NEWSOME FAMILY DIVISION SUBDIVISION

APPLICATION NUMBER 7 DATE October 2, 2014

REQUEST Subdivision

DETAIL SITE PLAN

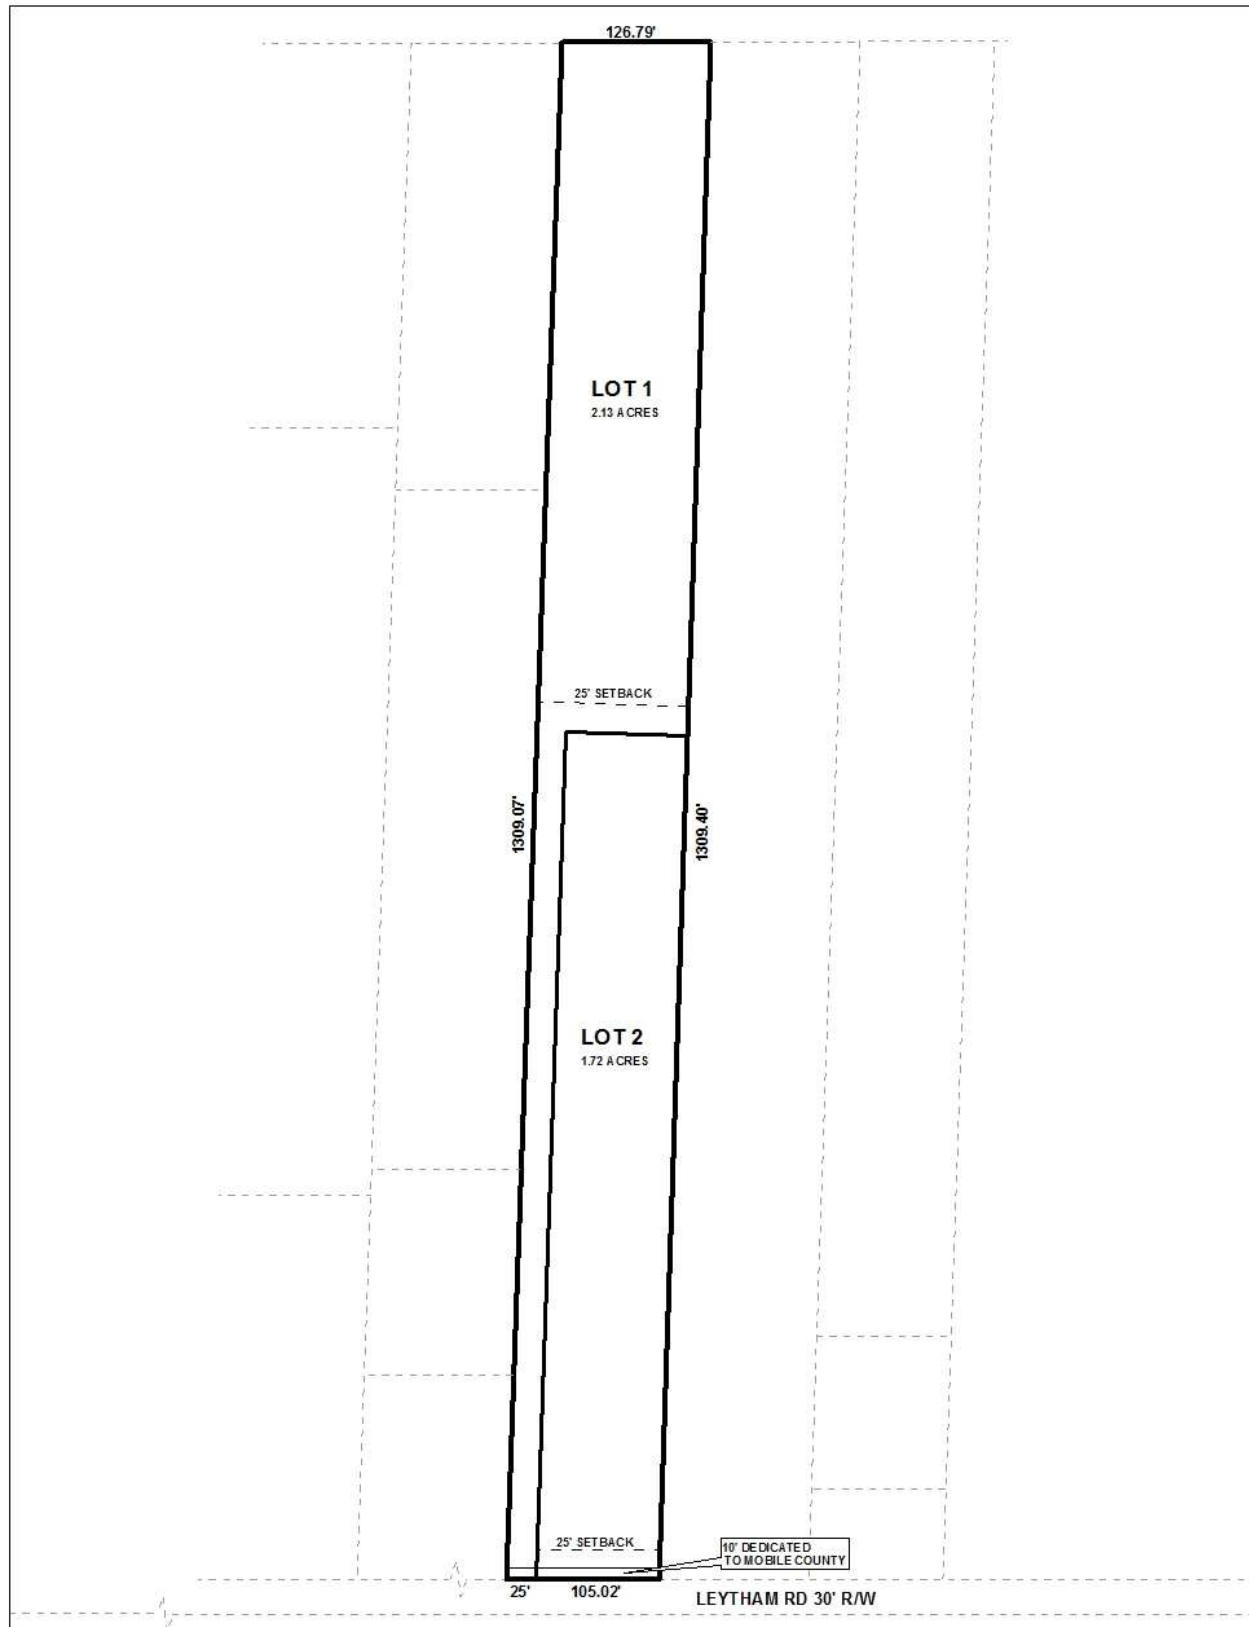
The 25' minimum building setback is shown on the preliminary plat, and should be placed on the Final Plat, if approved.

The preliminary plat depicts the lot sizes in acres but not in square feet. The lots should be labeled with the sizes in square feet and acres on the Final Plat, or a table should be furnished providing the same information, if approved.

It should be pointed out that the acceptance by owner signature block appears to illustrate the previous owner's name on the preliminary plat. Revisions should be made to the plat to illustrate the current property owner's name.

Staff does not recommend the proposed division of land on a substandard private street, and it should be pointed out that it appears that 4 adjacent properties to the west of the site currently access the existing strip of land/ proposed driveway for Lot 2. If the subdivision is approved as proposed, the adjacent property owners would be utilizing the "pole" of the proposed flag lot and may not legally have a way to access the private street (as no access easement information was provided or proposed).
